DATE: March 25, 2024

PROJECT NAME: A New Building for: Dalton Police Department
For The City of Dalton, GA

PROJECT NUMBER: 23-021

<u>PROJECT</u> DALTON POLICE DEPARTMENT	<u>JOB NUMBER</u> 2300112	<u>BY</u> MJL
<u>LOCATION</u> DALTON, GA.	<u>DATE</u> 03/22/2024	<u>DRAWING</u> SSK-1

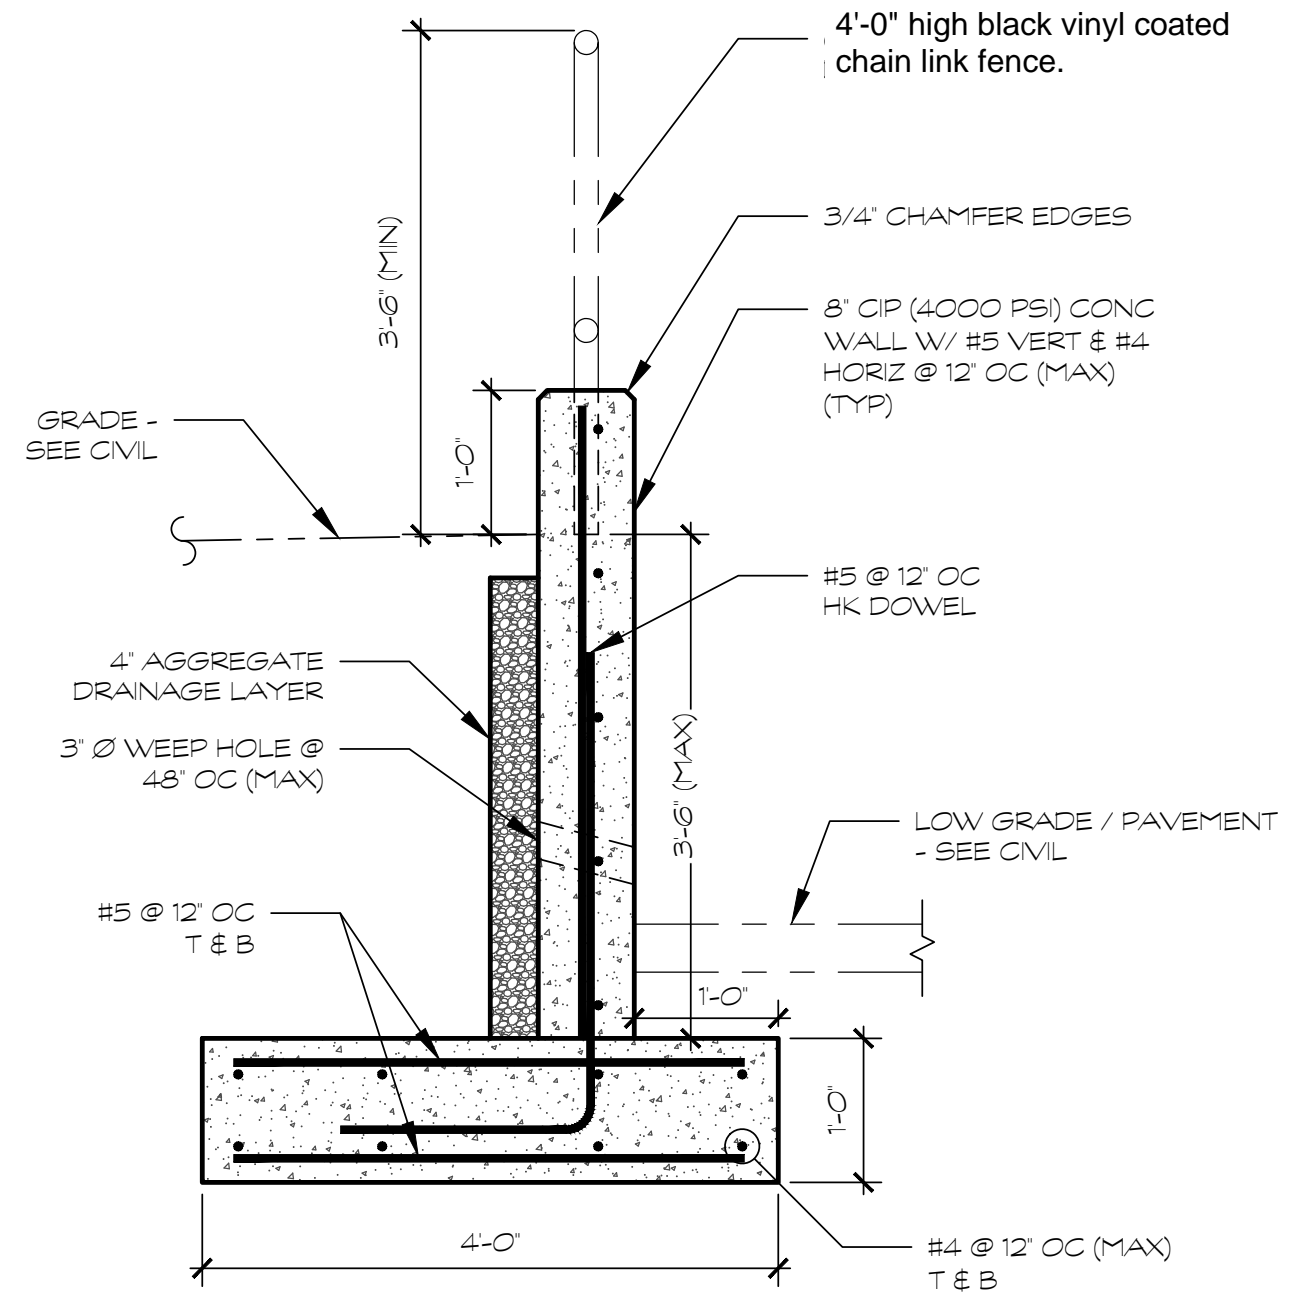
Item No. 4**SSK-1**

See attached SSK-1 for the retaining wall detail referenced on Sheet C2.
Note: The top of wall elevations shown on Sheet C3 shall all be increased by 12".
The chain-link fence shall extend along the entire length of the wall.
